COMMONWEALTH OF KENTUCKY
BEFORE THE PUBLIC SERVICE COMMISSION

ELECTRONIC 2022 INTEGRATED)	
RESOURCE PLAN OF EAST KENTUCKY)	CASE NO.
POWER COOPERATIVE, INC.)	2022-00098

RESPONSES TO JOINT INTERVENOR’S SUPPLEMENTAL INFORMATION

DATED AUGUST 30, 2022

Lamb Testimony Exhibit 1
Summary of Power Flow Analysis for Simultaneous Outages of Cooper Units 1 and 2

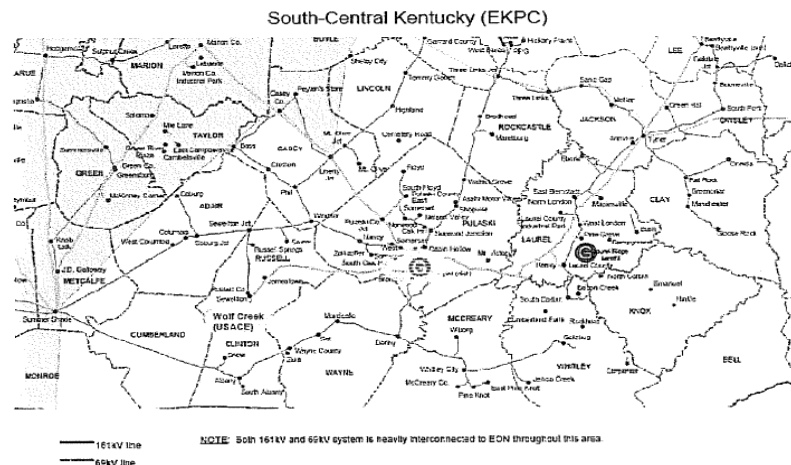
Request 21a. Approximately when did EKPC first become aware of that "the current transmission system is not configured to support the peak load periods in that region without the generation injections at Cooper Station"? Please provide the approximate month and year.

Response 21b. See Exhibit 1 to testimony submitted by James C. Lamb, Jr. in EKPC’s Application for a CPCN for construction of modifications to the water intake system at Cooper Power Station (Case No. 2007-00168) provided below.

Power flow analyses of EKPC’s 2007 Summer and 2007/08 Winter peak system models were performed to ascertain the ramifications of potential outages of the Cooper Station generating units. The south-central Kentucky area demand is met by four primary sources – the Cooper Station generating units, the Wolf Creek Dam generating units, the E.ON U.S. 345/161 kV transformer at Alcalde, and the Wolf Creek TVA-Russell County-Cooper 161 kV line. Additional support is provided to the area by the following EHV elements – the E.ON U.S. Pineville 345/161 kV transformer, the E.ON U.S. Pocket 500/161 kV transformer, and the Pocket (E.ON U.S.)-Phipps Bend (TVA) 500 kV line. As part of its normal planning process, EKPC evaluates an outage of any one of these sources to determine if transmission system reinforcements are required. EKPC also designs its system for an outage of any single generating unit in conjunction with an outage of a transmission line and transformer. Therefore, in this area EKPC evaluates an outage of Cooper Unit #2 plus an outage of any single line or transformer. However, due to the possibility of decreased water levels for Lake Cumberland that could eliminate the needed water source for the Cooper generating units, the possibility exists that both units could be off simultaneously during the summer. The transmission system must be designed to withstand an additional contingency for this scenario. Furthermore, the U.S. Army Corps of Engineers has informed EKPC that the hydroelectric generating units at the Wolf Creek Dam would be unavailable if the Lake Cumberland water level is lowered below 673 feet. This would eliminate an additional generation source for the area.

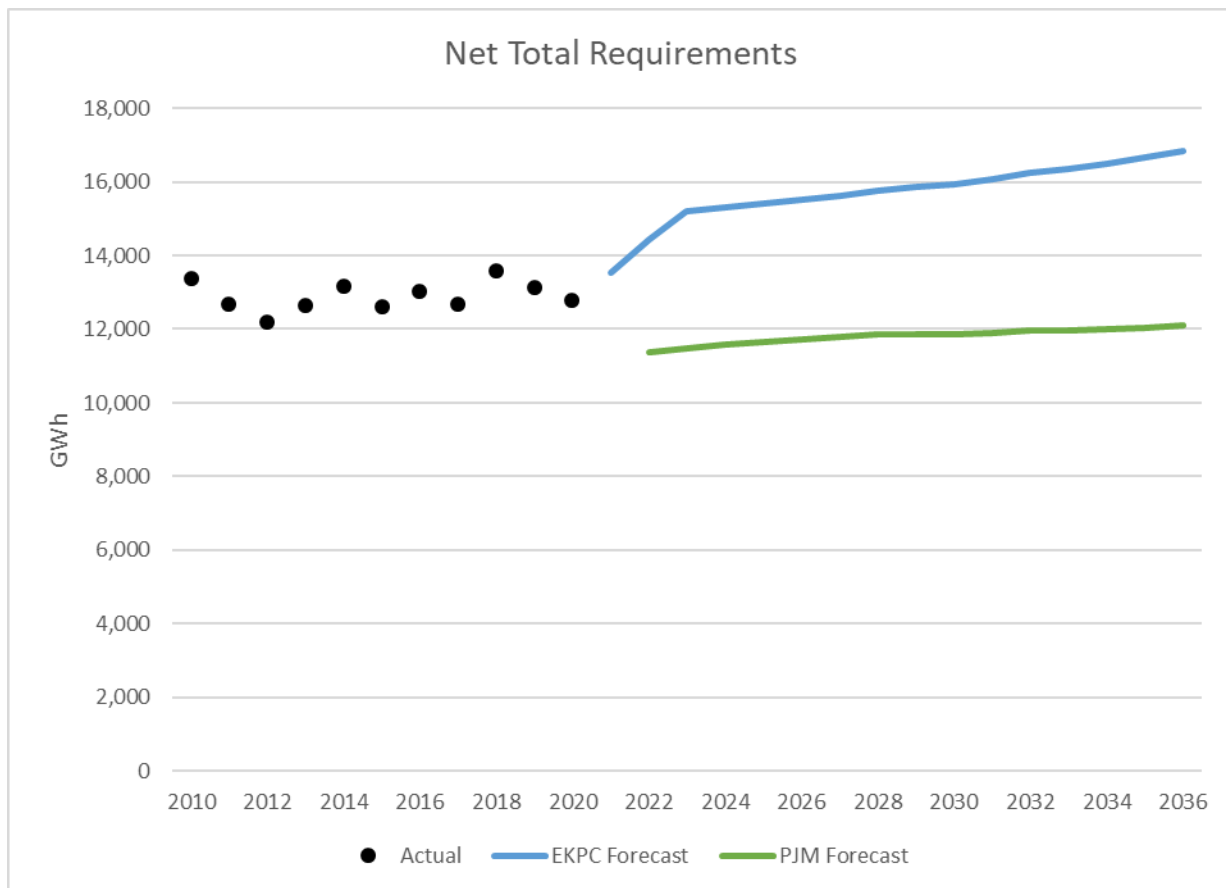
Request 37. Please refer to EKPC response to Joint Intervenor Request No 1 – Figure 1-1, Figure1-2, Figure_1-3, Columns E and S of the tab “Data for Graphs”. The 2022 PJM Load Forecast Report projects 0.4% growth in total annual energy requirements between 2022 and 2036, and 0.4% growth in the winter peak load demand for the same period. EKPC projects growth rates of 1.1% for total annual energy requirement, and 0.6% for its winter peak demand. Can EKPC explain the difference between its forecasts of winter peak load and total energy requirements and PJM’s?

Response 37. The PJM and EKPC forecasts are not the same series. EKPC’s forecast is developed according to its work plan and the requirements of RUS. Economic assumptions are based on owner-member share of county-level projections. Appliance saturations are based on an end-use survey as required by RUS. The EKPC forecast also incorporates known changes to industrial Customers. These assumptions may not be the same as the PJM load forecast. Additionally, the resulting forecasts are different. A graph of historical net total energy requirements along with the EKPC and PJM load forecast are included below. The PJM forecast

is below historical actual indicating that it is not comparable to the EKPC total energy requirement forecast. The PJM forecast is for the load tied directly to the EKPC transmission system. It includes some load for LG&E/KU which is served from the EKPC system and it does not include the EKPC load that is served from the LG&E/KU transmission system. The two forecasts are not directly comparable without significant modifications to the PJM forecast.
